MORIN BUILDING
8570 EXECUTIVE PARK AVENUE
FAIRFAX, VIRGINIA 22031

Subject: Addendum 2, RFP 22-040, Hosting Services

Fairfax Water's SAP Landscape

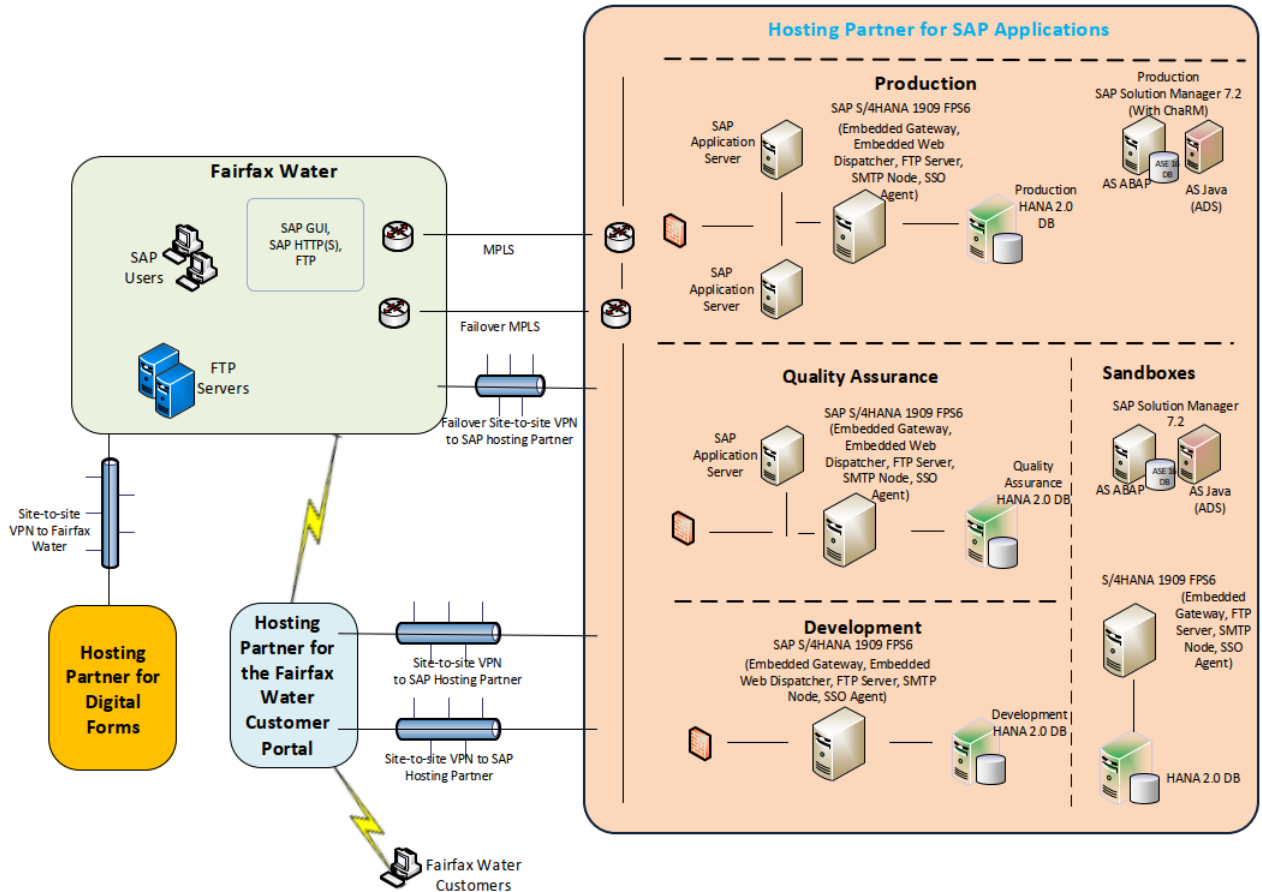
RFP 22-040 – Addendum 2 – Attachment H – Hosted SAP Landscape – Updated Architecture Diagram to reflect S/4 HANA systems. This replaces Attachment H – Hosted SAP Landscape in the RFP.
